Response to objection letter prepared on behalf of Marble Beers Ltd and Heritage Statement

Thank you for forwarding on the objection letter prepared by Plan:8 Town Planning Ltd on behalf of Marble Beers Ltd and the Heritage Statement prepared by Jenny Whetton Conservation also on behalf of Marble Beers Ltd.

Figure 1 – Pedestrian wind conditions, proposed development within existing surrounds, annual safety

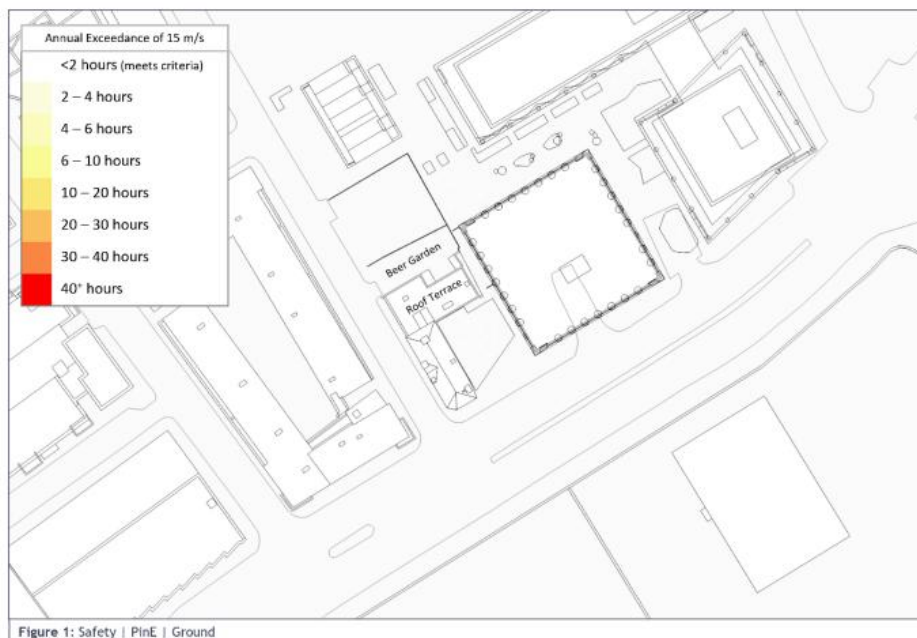
In relation to Wind Microclimate, the objection letter states that:

“the assessment appears principally focused on circulation routes, entrances and the applicant’s own public realm not upon the impact of wind on the private roof terrace of the Marble Arch or the beer garden.”

The Wind Microclimate Report, dated 25 March 2026, demonstrates the results for the conditions at the private roof terrace of the Marble Arch and the beer garden. These are presented graphically in Figure 1 for safety (also presented as Figure 11 in the Wind Microclimate Report, March 2026) and Figure 2 for summer comfort (also presented as Figure 13 in the Wind Microclimate Report, March 2026)

Following the introduction of the proposed development within the existing surrounds configuration, there remain no exceedances of the safety criteria at the private roof terrace of the Marble Arch and the beer garden. The wind conditions within these areas are suitable for long-term sitting during summer, and therefore suitable for prolonged periods of outdoor seating.
